Notice of Allowability	Application No.	Applicant(s)
	10/577,044	SHIGEMATSU, RYOHEI
	Examiner	Art Unit
	Cindy D. Khuu	2863

DETAILED ACTION

Examiner's Amendment

FIG.1

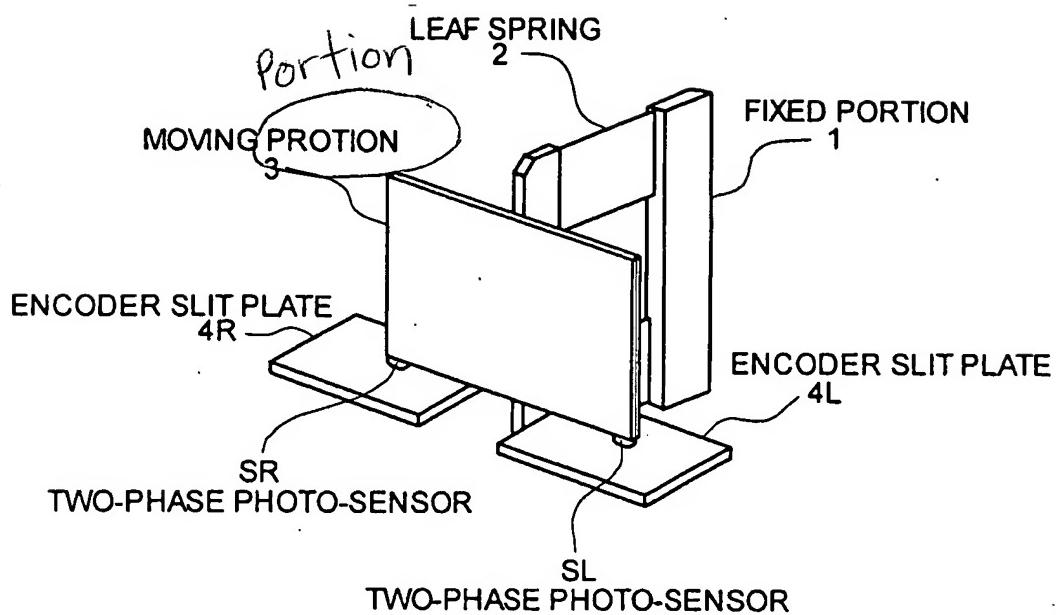
Attachment Markup sheet of Fig. 1, indicates the typographical error to be corrected.
